Site Audit Report and Site Audit Statement for the Remedial Action Plan, Hydro Aluminium Kurri Kurri Smelter Site Audit

Part B2 - Appropriateness of RAP for Smelter Area

06-Jul-2018

Appendix G Conceptual Cell Design

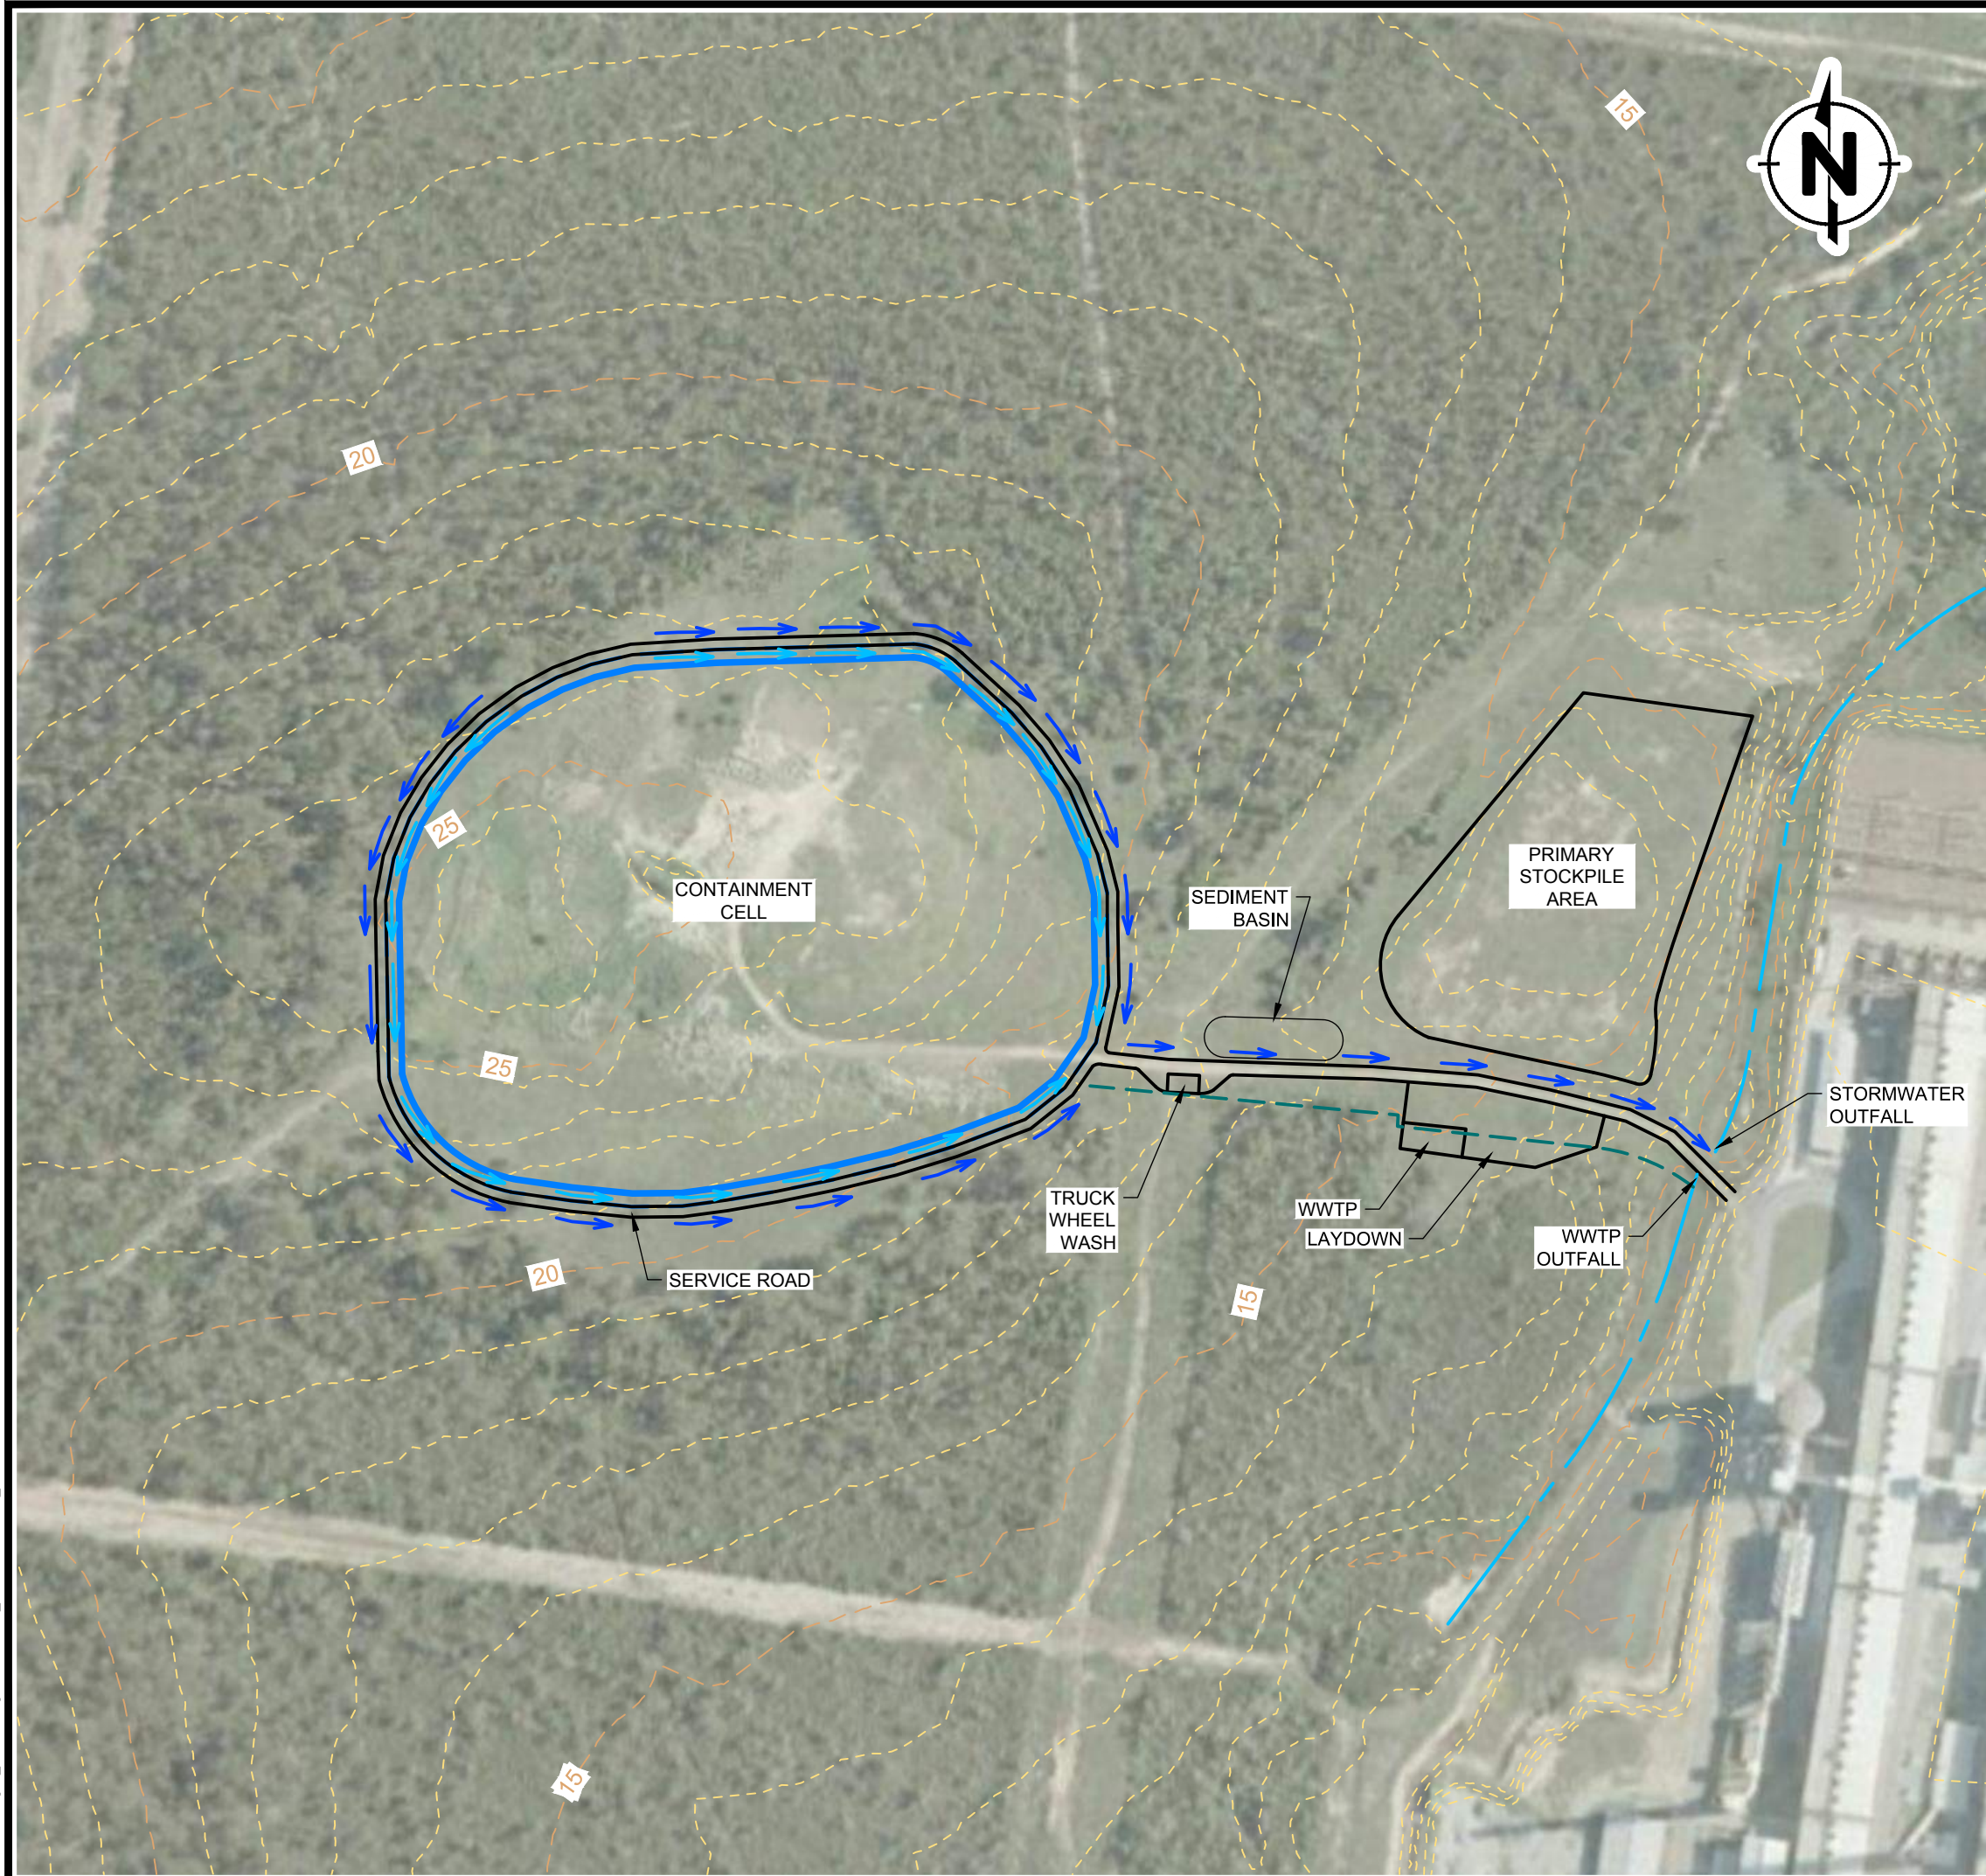
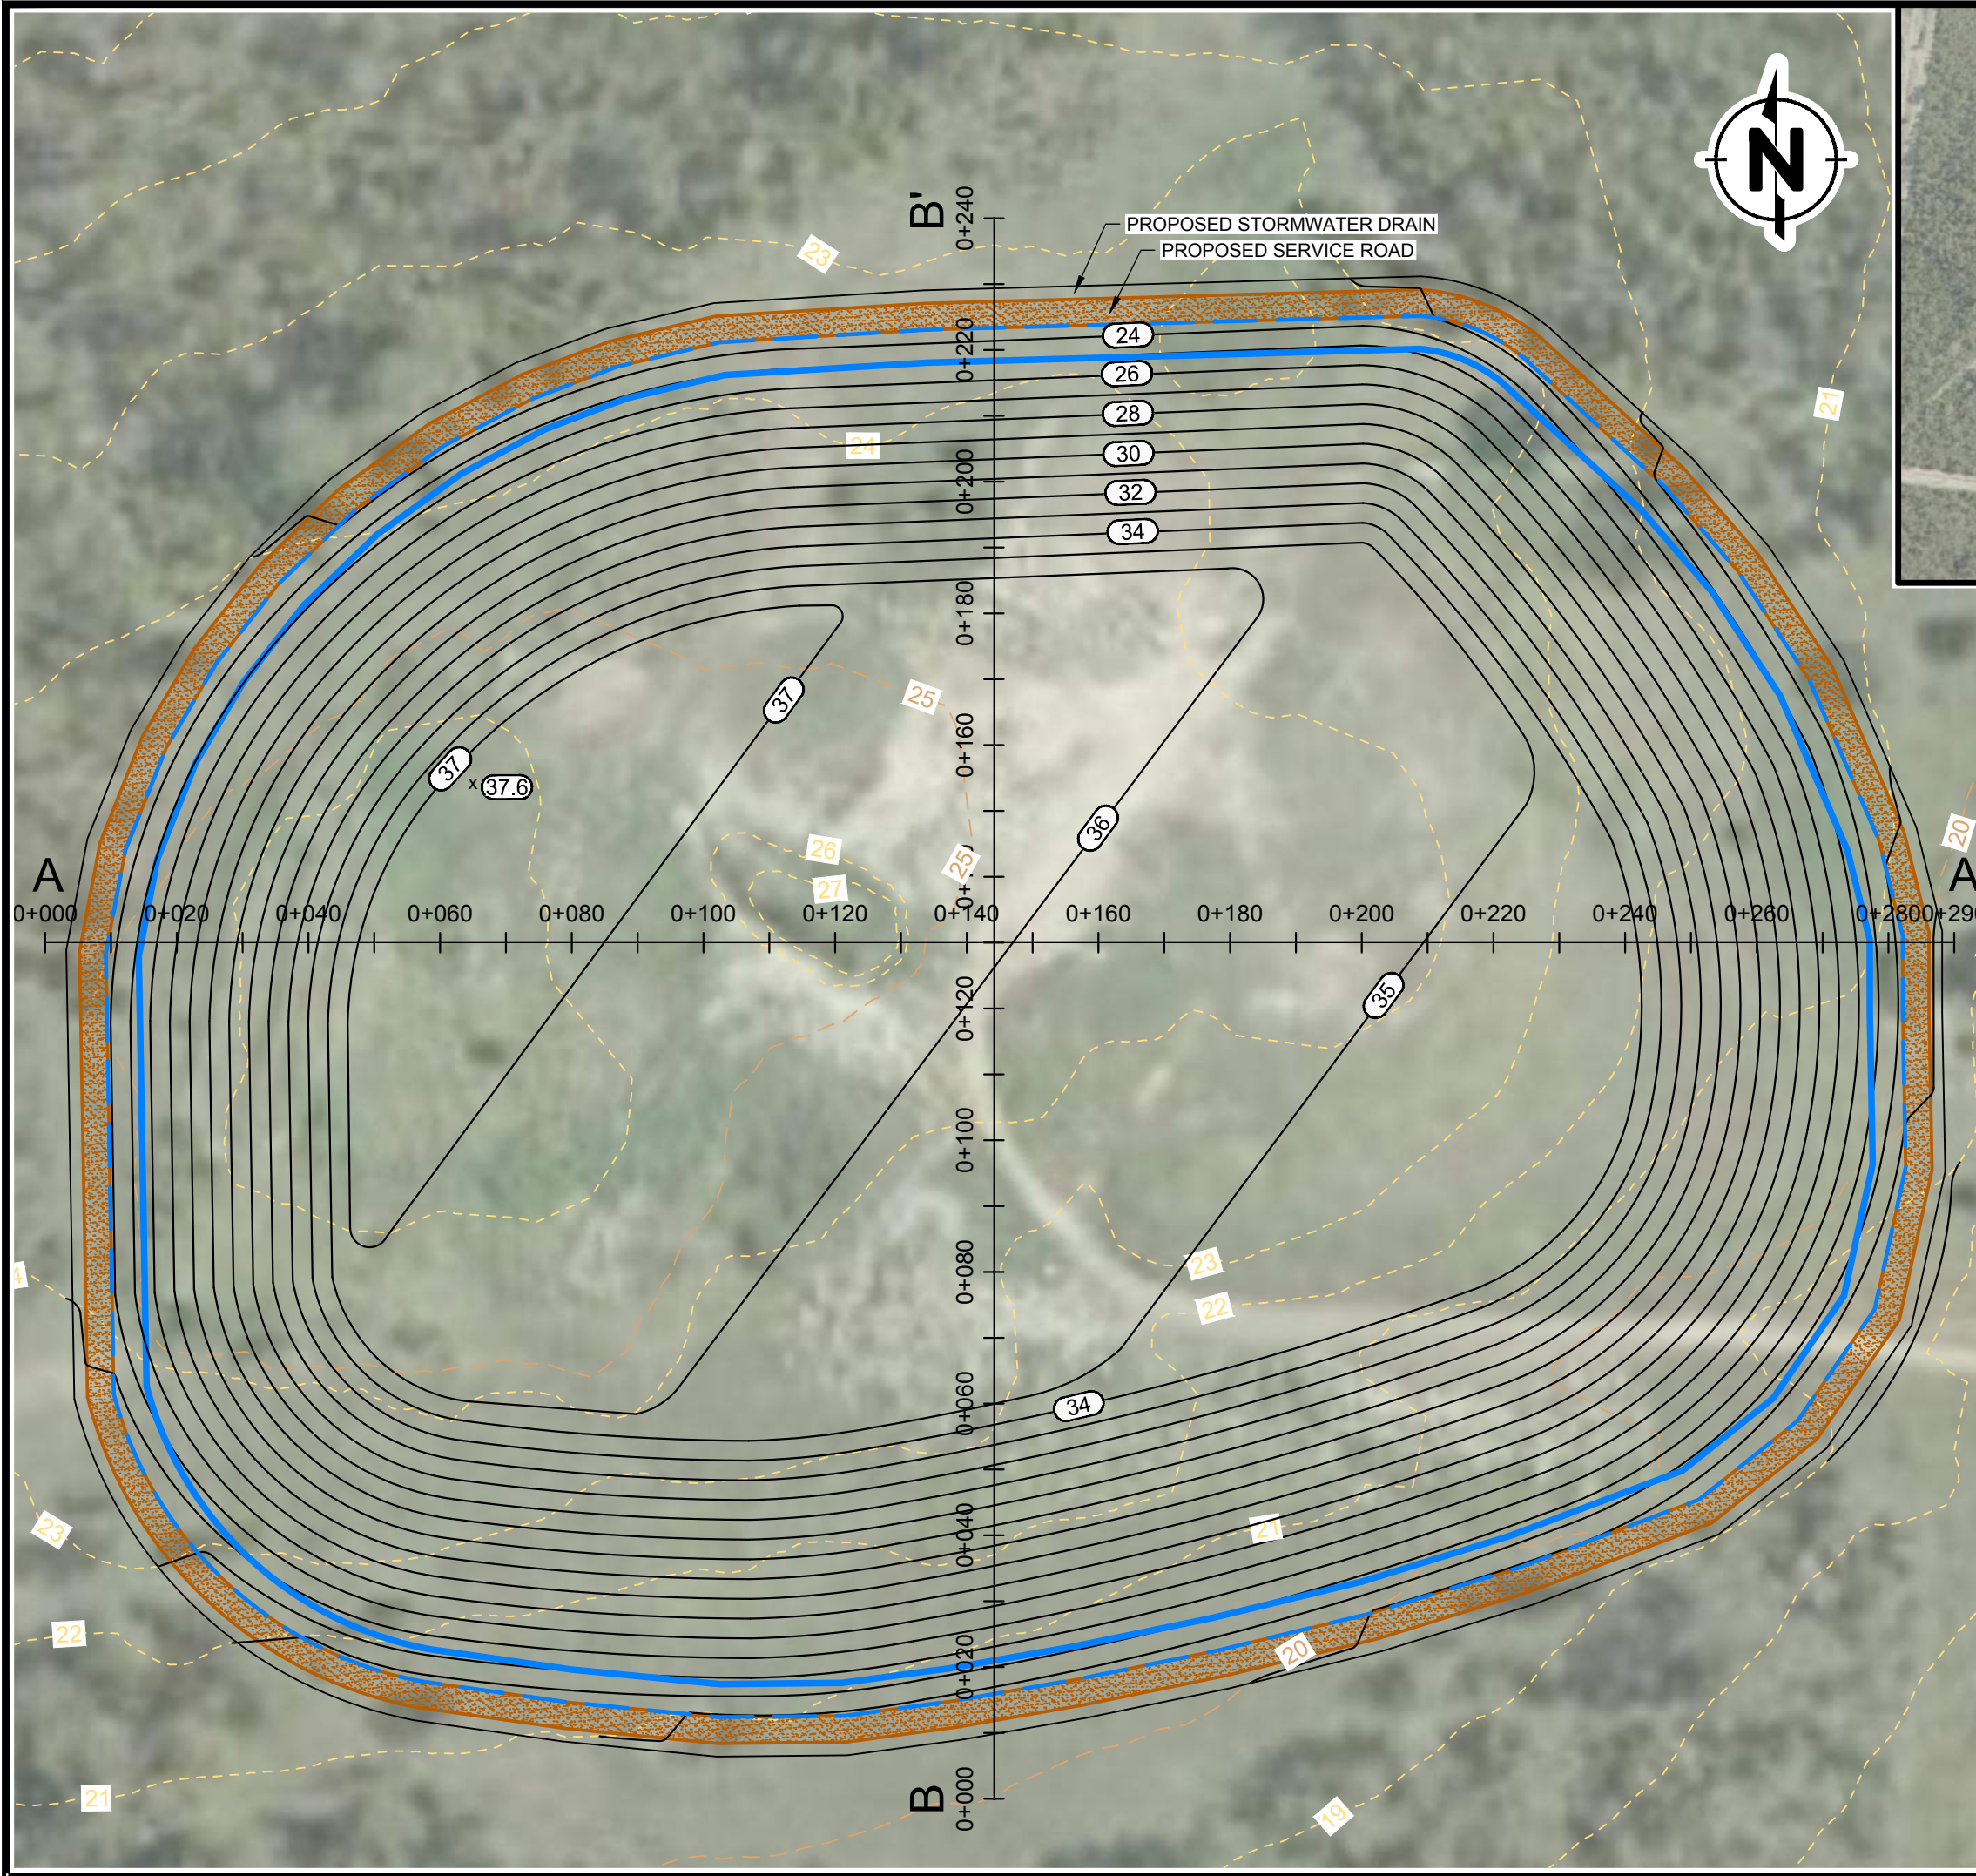
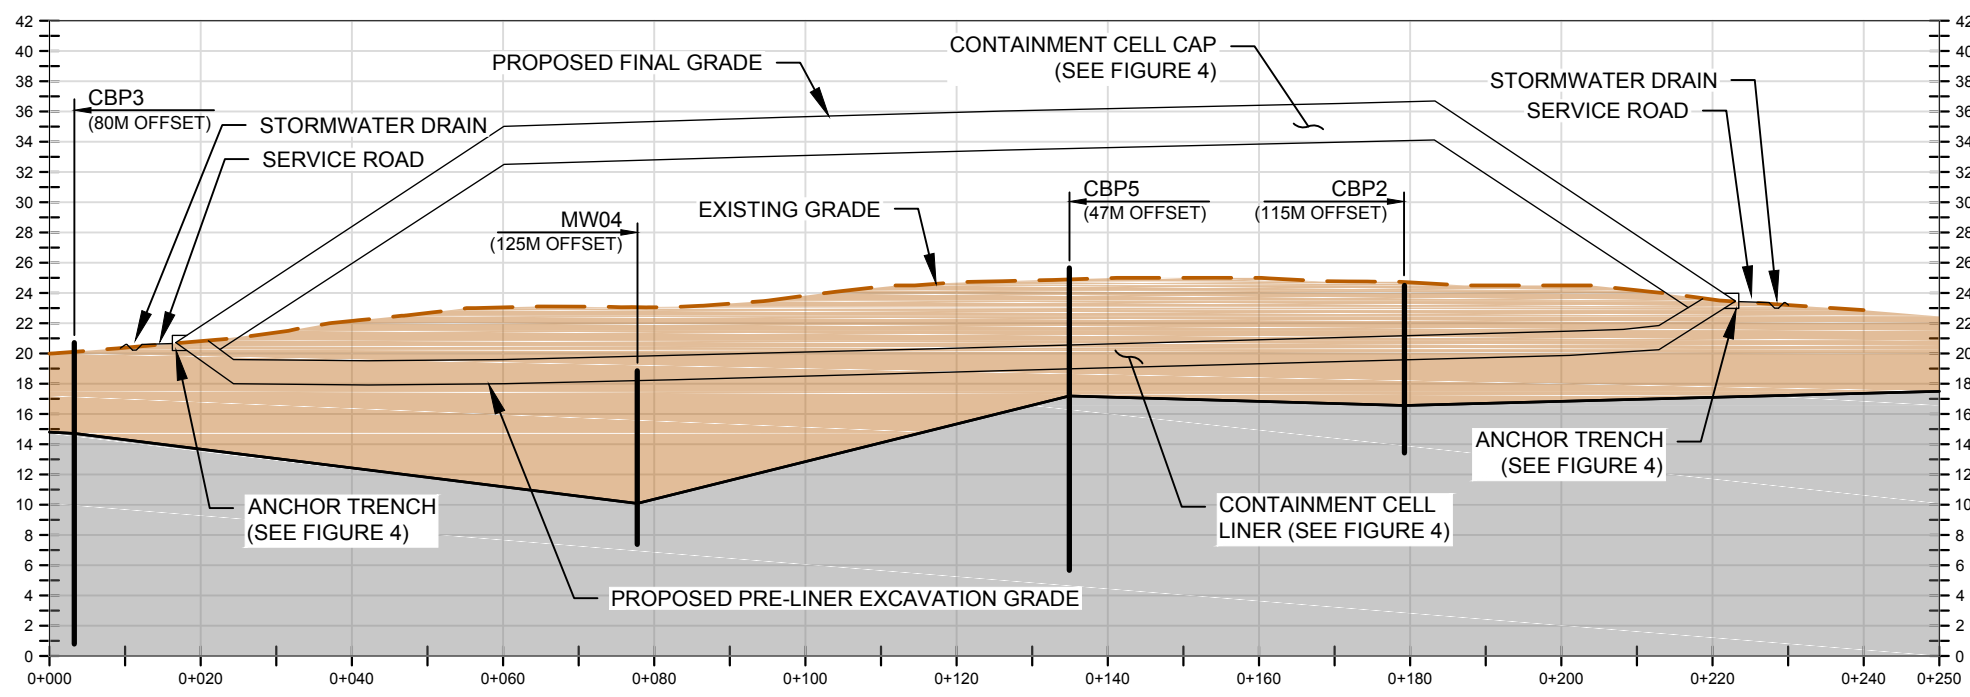
6	That the suitability of the containment cell design be independently verified.	This comment has been identified by NSW EPA to ensure the proposed containment cell meets current best practice and is appropriate for the degree and extent of contamination identified in the material to be placed in the containment cell.
